Bi-weekly Seismic Call Minutes

Date: 2016-05-03

1. RAI 199-8223, Question 03.08.01-11

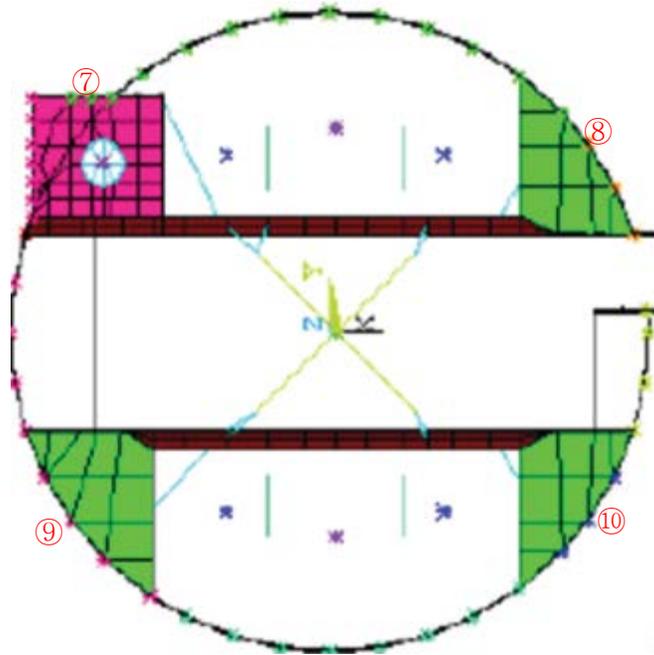
KHNP is to determine what slabs have been included in the live load study, re-perform the study if all slabs have not been included, and revise the RAI response to describe the modeling of all slabs and discuss the treatment of live loads with regard to those slabs (justify if excluded).

There are some small horizontal surfaces in the reactor containment building other than those horizontal surfaces between the secondary shield wall (SSW) and the containment shell. The small horizontal surfaces which are not between the SSW and the containment shell are modeled in the reactor containment building seismic analysis model. The following figure shows the horizontal surfaces modeled in the reactor containment building seismic analysis model compared to those those horizontal surfaces shown in DCD Tier 2, Figure 1.2-2, "General Arrangement Reactor Containment Building Section A-A"

In addition to the six horizontal surfaces shown in the figure above, four horizontal surfaces also exist in the reactor containment building, as shown in the figure below.

Since the ten horizontal surfaces labeled above are relatively small, the seismic live loads of those surfaces were ignored in the last study for evaluation of seismic live load effect on seismic response of the reactor containment building.

The main issue that the NRC has is that the adequacy of the reactor containment walls is discussed, but the slab also needs to be addressed. Specifically whether the slab is considered flexible or rigid and if flexible, how is it determined that the mesh is adequate for the increased frequency response? How is out-of-plane behavior addressed in the modeled and non-modeled cases?

Therefore, the revised ISRS comparisons, which show the effect of seismic live loads distributed on all horizontal surfaces as well as those horizontal surfaces between the SSW and the containment shell, are provided below. As shown in the figures below, the comparison results indicate that the variation of ISRS due to the consideration of the seismic live load in the RCB seismic analysis model is negligibly small. Therefore, it can be concluded that the effect of seismic live load on the RCB seismic response is insignificant.

The total weight of the seismic live load which is included in this evaluation is 1,650 kips, while the total weight of the reactor containment building internal structure is 183,000 kips.

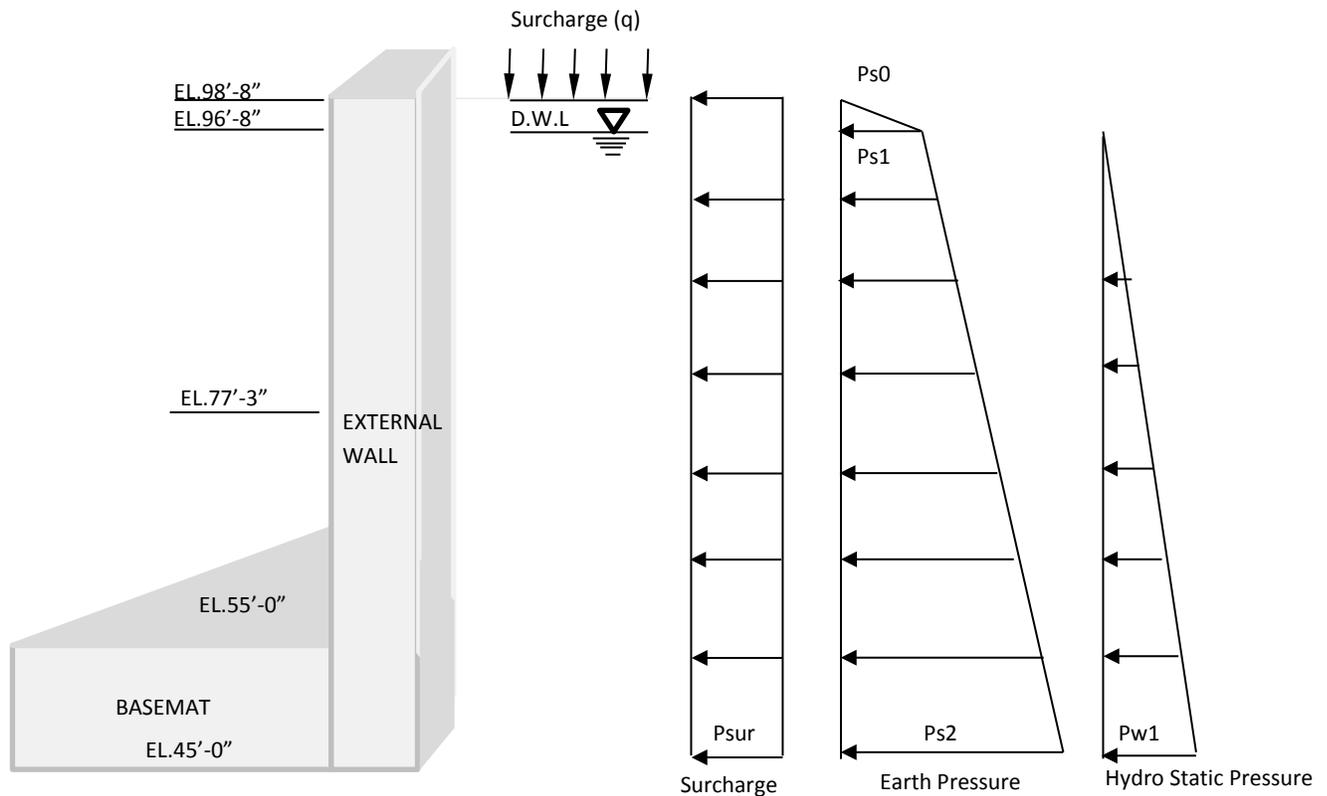
KHNP is to provide the revised response which includes the EDGB & DFOT.

KHNP is experiencing technical challenges. An investigation of how previous applicants have resolved contact ratio issues is underway. KHNP anticipates being able to provide a draft due date during the next bi-weekly call on 2016-05-18.

The staff reiterated that they agree with the methodology used for the nuclear island and expects that the same be used for the EDGB and DFOT. They understand that the technical challenges have been resolved and will look forward to reviewing the draft response soon.
